# SAN FRANCISCO PLANNING DEPARTMENT

## Discretionary Review

### Full Analysis

*Date:* May 30<sup>th</sup>, 2013  
*Case No.:* 2006.0647DD  
*Project Address:* 2166 12<sup>TH</sup> AVENUE  
*Permit Application:* 2005.06.23.5892  
*Zoning:* RH-1 (Residential, House, One-Family) Zoning District  
40-X Height and Bulk District  
*Block/Lot:* 2206/036  
*Project Sponsor:* Suheil Shatara  
26 Lakeview Drive  
Daly City, CA 94015  
*Staff Contact:* Tom Wang – (415) 558-6335  
[thomas.wang@sfgov.org](mailto:thomas.wang@sfgov.org)  
*Recommendation:* **Take DR and approve with modification.**

### 2166 12<sup>th</sup> Ave Rear Elevation.

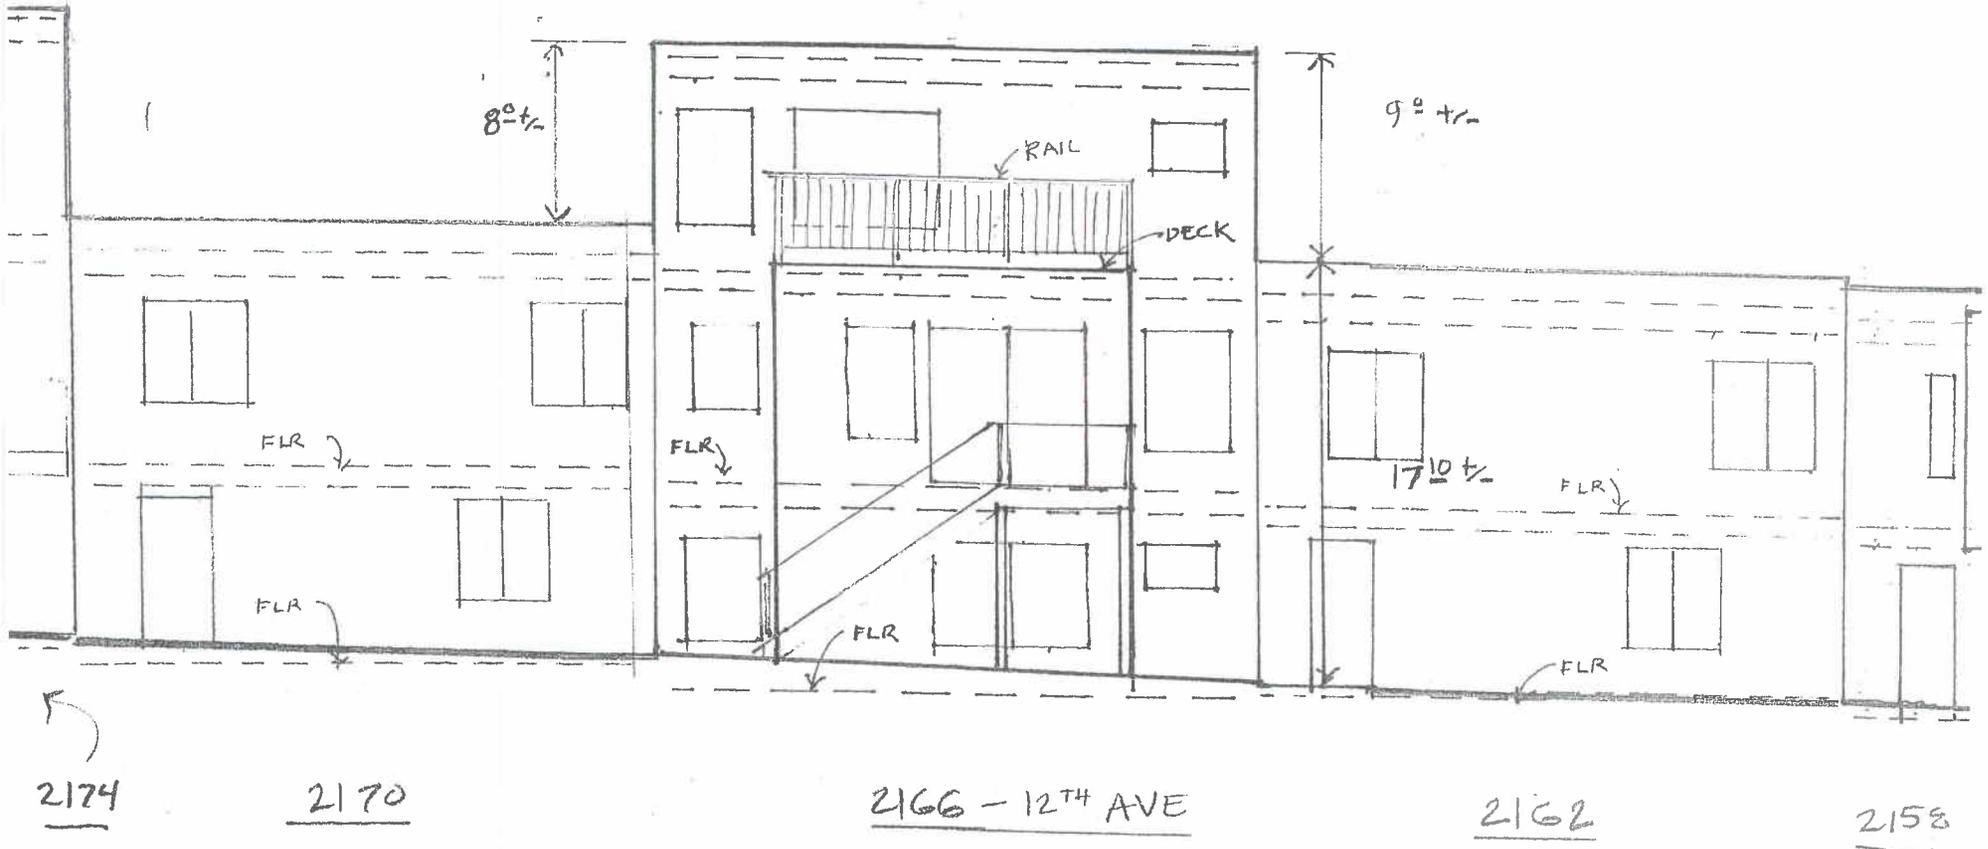
Massive addition, out of scale with neighboring homes.

Roof-top deck will result in lack of privacy for adjacent homes.
